Project Narrative – Aretha Franklin Amphitheatre

CHENE PARK AMPHITHEATER

ST1

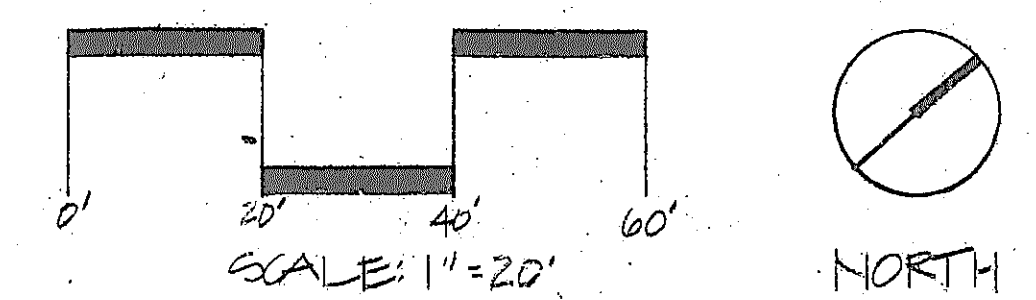
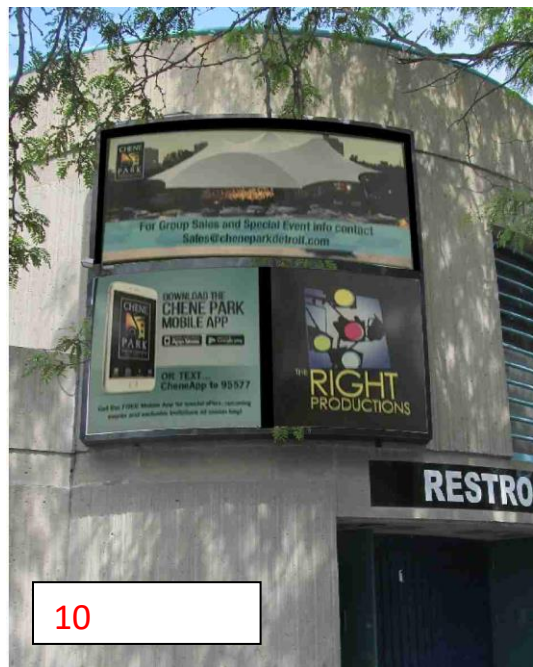
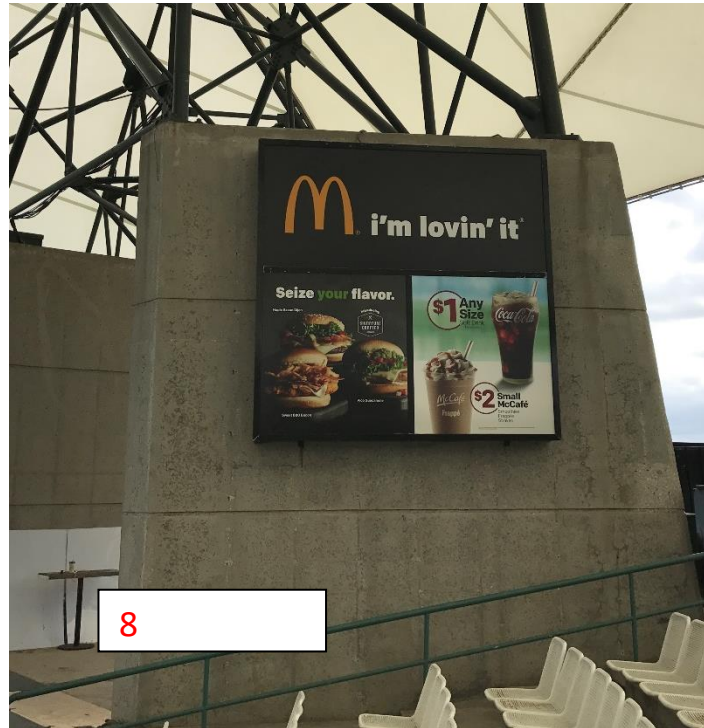
* The bottom 2 faces will have to be cut down to fit the bottom cabinet. Once they are cut they can't go back in the original cabinet.

* The red area is where we would need to add panels to fill in the space where the faces don't cover.
